NLT Product Change Notice PCN Tracking Number: NLT-PP-6396

Type name	
NL6448BC26-26	NL6448BC26-27
NL6448BC26-26D	NL6448BC26-27D
NL6448BC26-26C	NL6448BC26-27C
NL6448BC26-26F	NL6448BC26-27F

5. Nameplate label

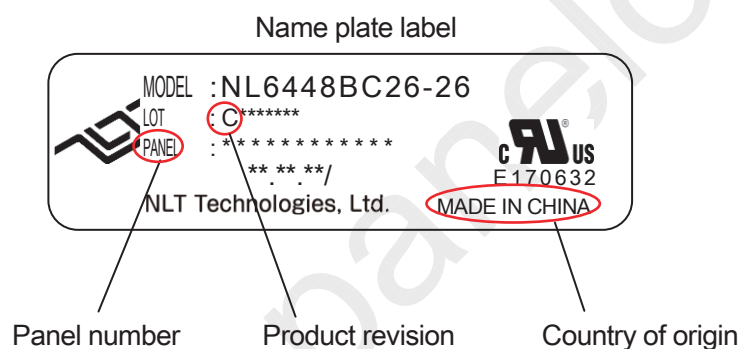
Information of country of origin on the nameplate label will be changed as follows.

Country of origin	Current	After change
	MADE IN JAPAN	MADE IN CHINA

NL6448BC26-26, -26D, -26C, 26F
Back side of the product

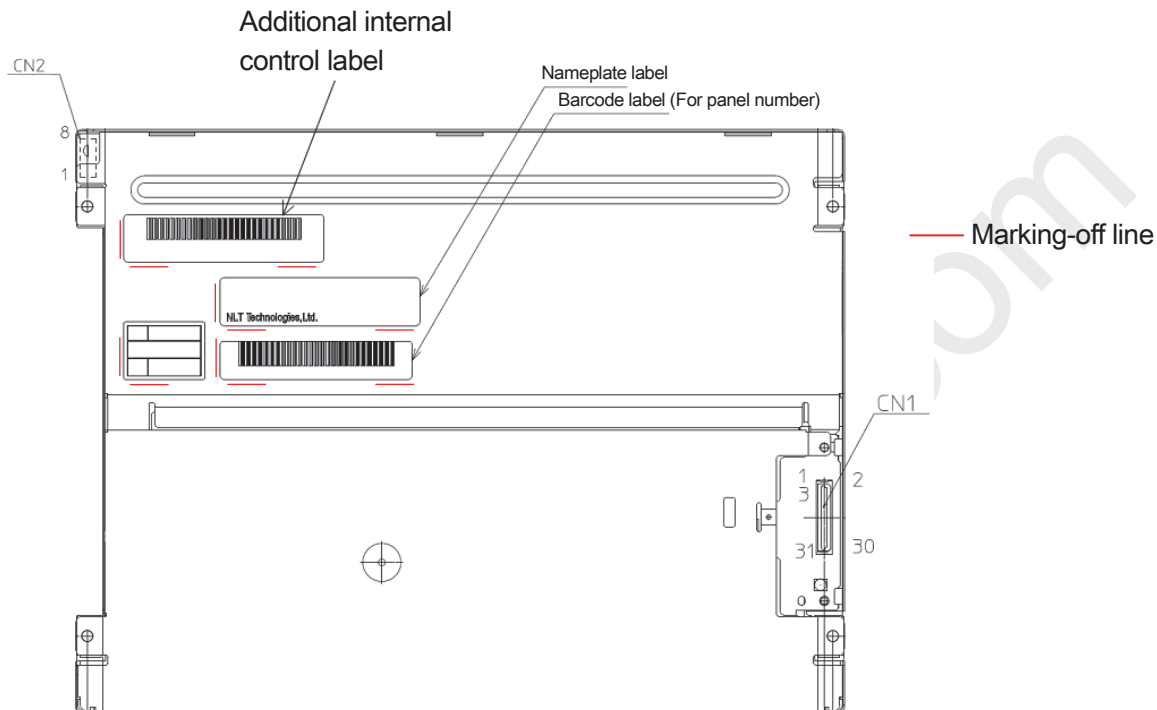
Item	Description
TFT panel production	No change TFT panel is produced at Akita production site as before.
Module assembly	Module assembly site will be changed from Akita production site to China production site.
FPC	Supplier of the FPC which is used at inside the product will be changed. No wiring pattern and shape of the FPC will be changed.
Backlight	Backlight supplier will be changed. No optical specifications will be changed.
Metal chassis	Metal chassis supplier will be changed. No shape and material of the metal chassis will be changed.
Nameplate label	<ul style="list-style-type: none"> • Country of origin MADE IN JAPAN → MADE IN CHINA • Panel number The number of digits: 13 digits → 12 digits Please refer to page 2/4.
Internal control label	The internal control label will be added on the back side of the product. Please refer to page 3/4.
Marking-off line	Marking-off lines for reference of label attachment position will be added on the back side of the product.
